Planning and Development Services
Arun District Council
Arun Civic Centre
Maltravers Road
Littlehampton
West Sussex
BN17 5LF

Developer Services
Southern Water
Sparrowgrove House
Sparrowgrove
Otterbourne
Hampshire
SO21 2SW

PLAN-012026

Proposal: Two storey extension, single storey extension & new porch.
Site: Langham Legh, Barnham Road, Eastergate, PO20 3RP.
EG/43/15/HH

Southern Water MapGuide Browser

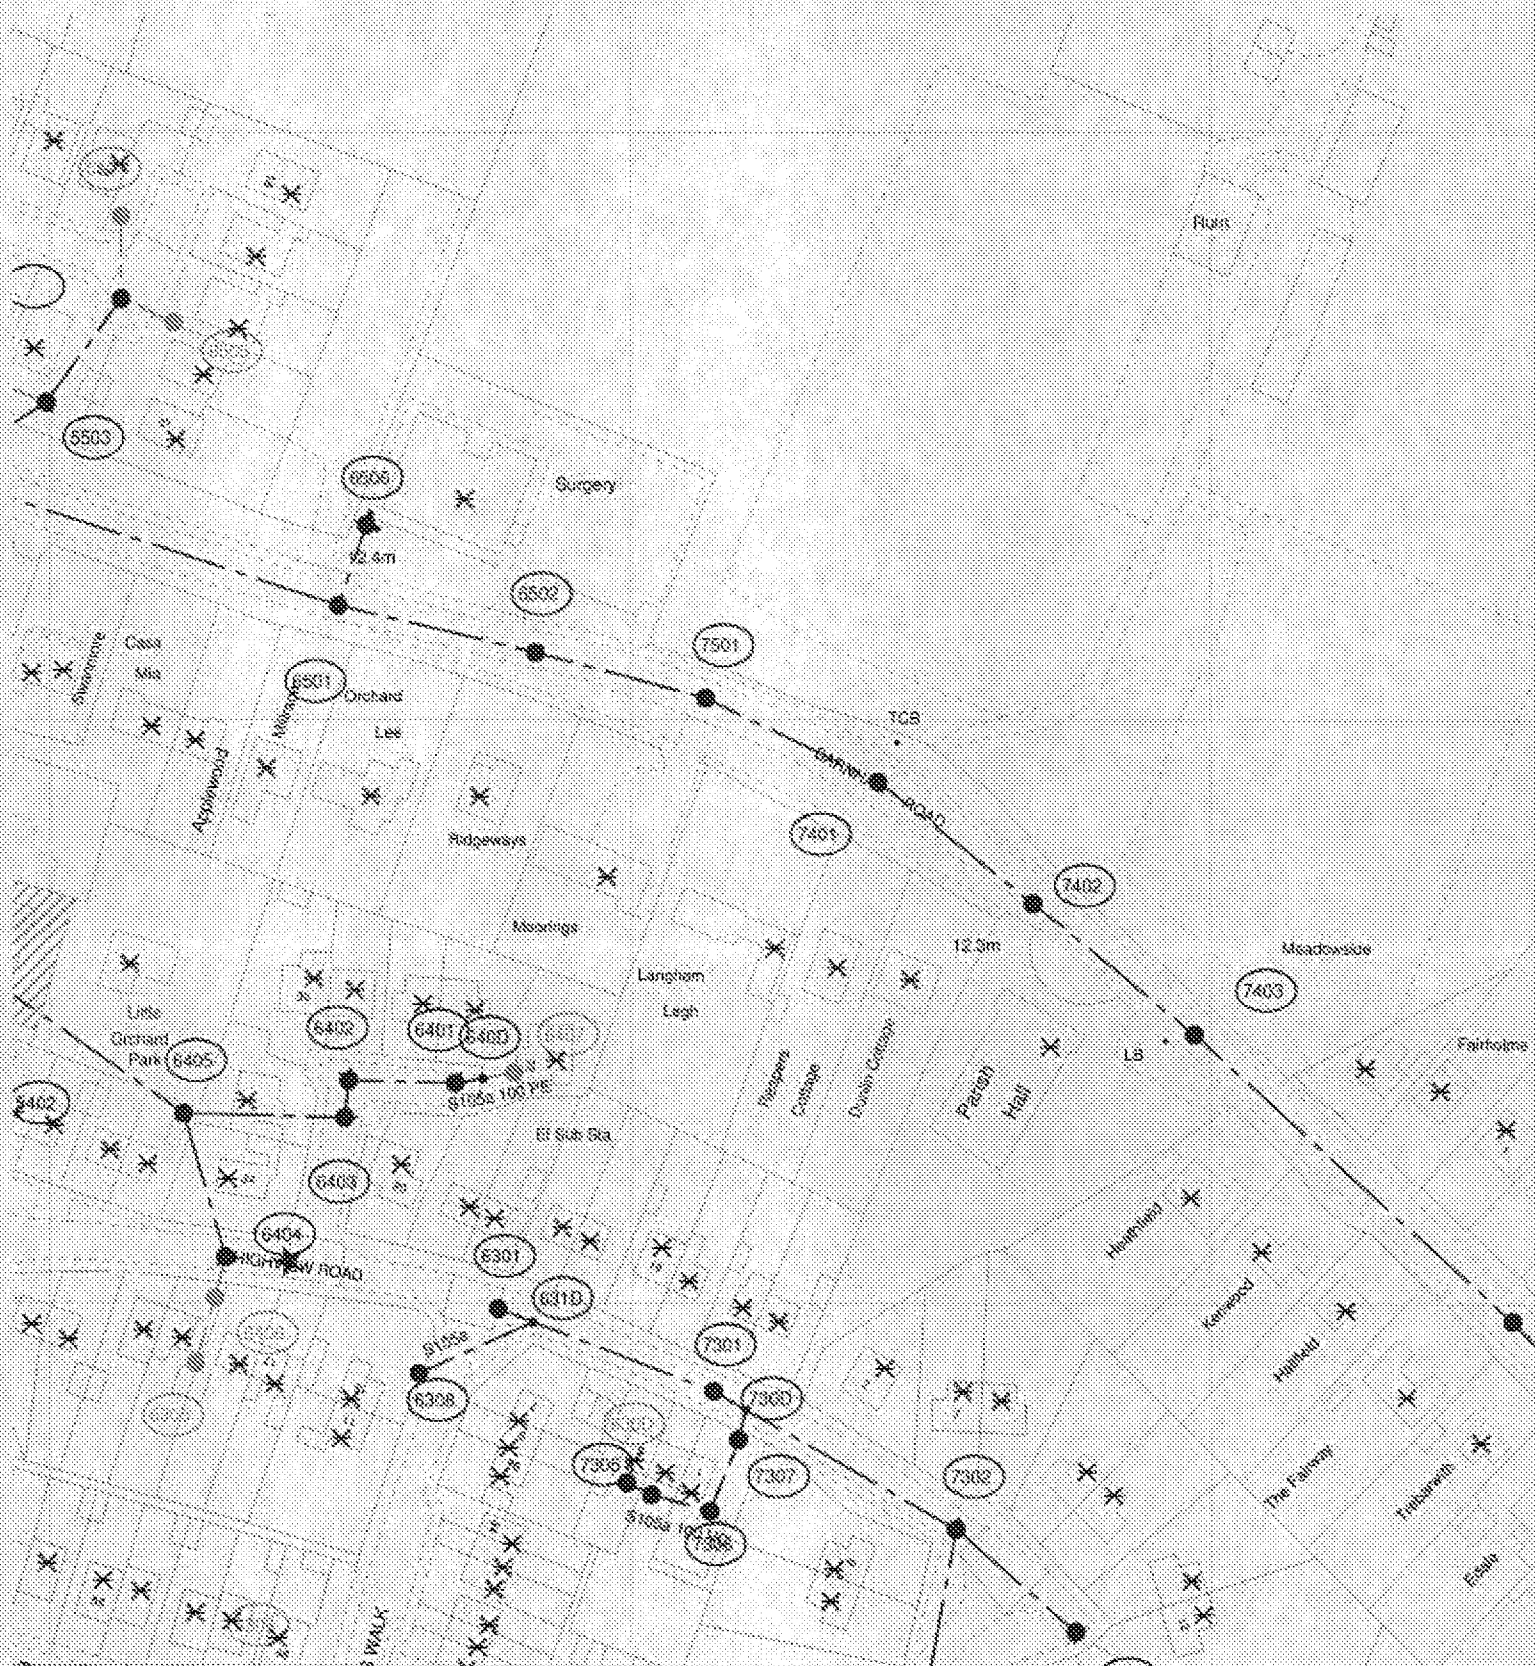
Our initial investigations indicate that there are no public surface water sewers in the area to serve this development. Alternative means of draining surface water from this development are required. This should not involve disposal to a public foul sewer.

Due to changes in legislation that came in to force on 1st October 2011 regarding the future ownership of sewers it is possible that a sewer now deemed to be public could be crossing the above property. Therefore, should any sewer be found during construction works, an investigation of the sewer will be required to ascertain its condition, the number of properties served, and potential means of access before any further works commence on site. The applicant is advised to discuss the matter further with Southern Water, Sparrowgrove House, Sparrowgrove, Otterbourne, Hampshire SO21 2SW (Tel: 0330 303 0119) or www.southernwater.co.uk".

Developer should look to protect the public sewerage system from inundation and infiltration, which contribute to flooding in unfavourable conditions.
